November 22, 1982

Subject: Dresden 2  
SEP Topic: III-2, Wind and Tornado Loadings

NRC Docket 50-237

FIGURE 1 TORNADO HAZARD PROBABILITY MODEL FOR DRESDEN  
(With 95% Confidence Limits)

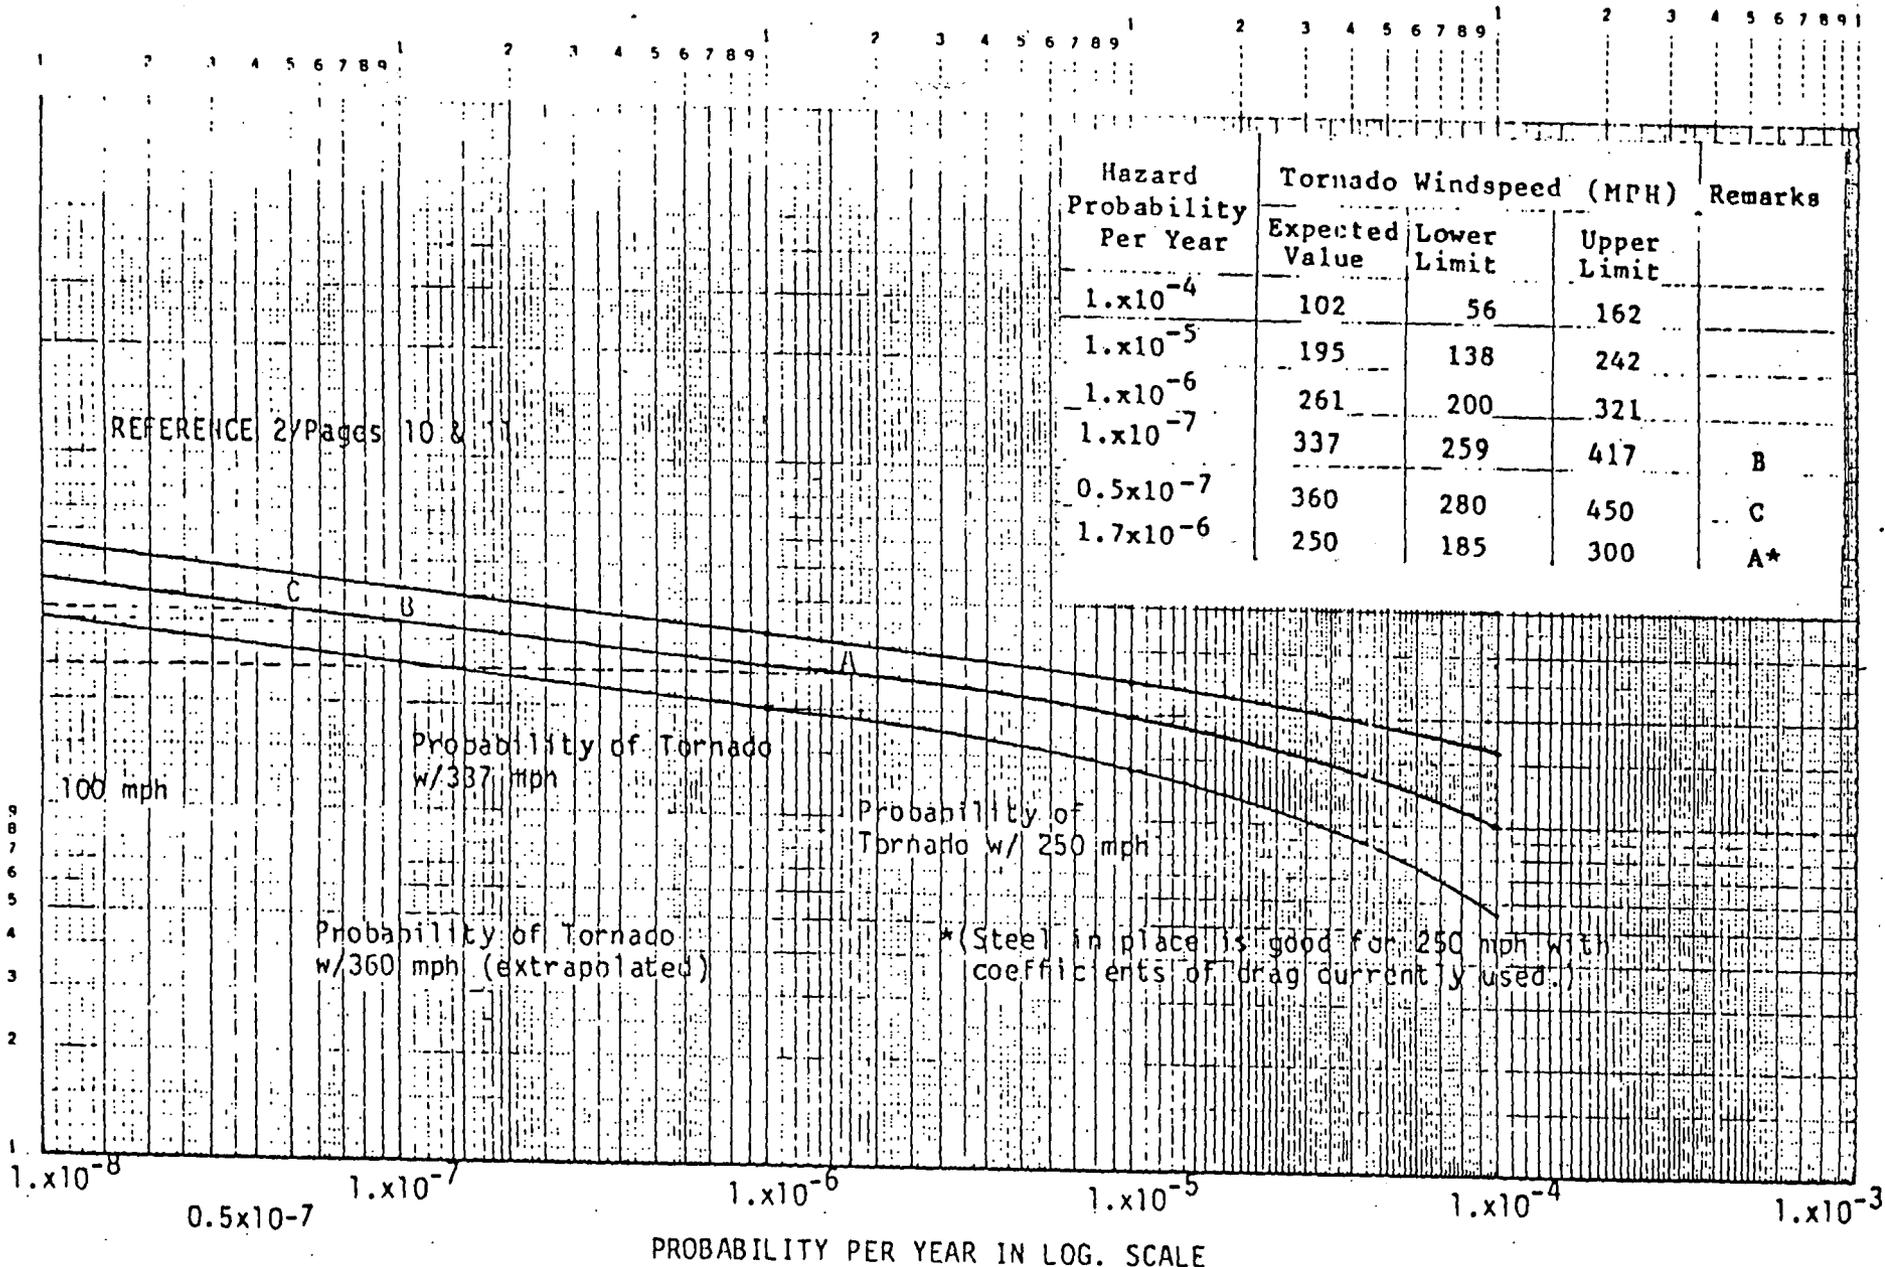
Roof decks consisting of built-up roofing as opposed to structural roof slabs made of concrete were not investigated by the staff. It is expected that such roofs will have minimal resistance to differential pressure. Therefore, it is the staff's position that the licensee provide an evaluation of demonstrate that failure of roof decks will not adversely affect safe plant operation or result in unacceptable offsite dose consequences.

Since the theoretical wind velocity capacity of the metal wall siding panels around the reactor building is less than the ultimate uplift capacity of the roof panels, we have considered an open building for the evaluation of the roof panel capacity. The ultimate capacity of the precast roof slabs for uplift is 130 psf. The tornado windspeed required to produce this uplift is 320 mph. The NRC staff evaluation of Topic II-2.A, "Severe Weather Phenomena", included a probability analysis of tornado windspeeds. The mean probability of exceeding a tornado windspeed of 320 mph is approximately  $2 \times 10^{-7}$  per year (figure 1).

The actual structural behavior would be between the totally open and totally closed building. In any event, the tornado wind load capacity is acceptable. Because of the low probability of exceeding a tornado windspeed sufficient to fail the roof slabs, the rapid dispersion of any postulated radiological release due to the turbulent nature of tornado winds, Commonwealth Edison concludes that upgrading of the roof to withstand higher tornado windspeeds is not warranted.
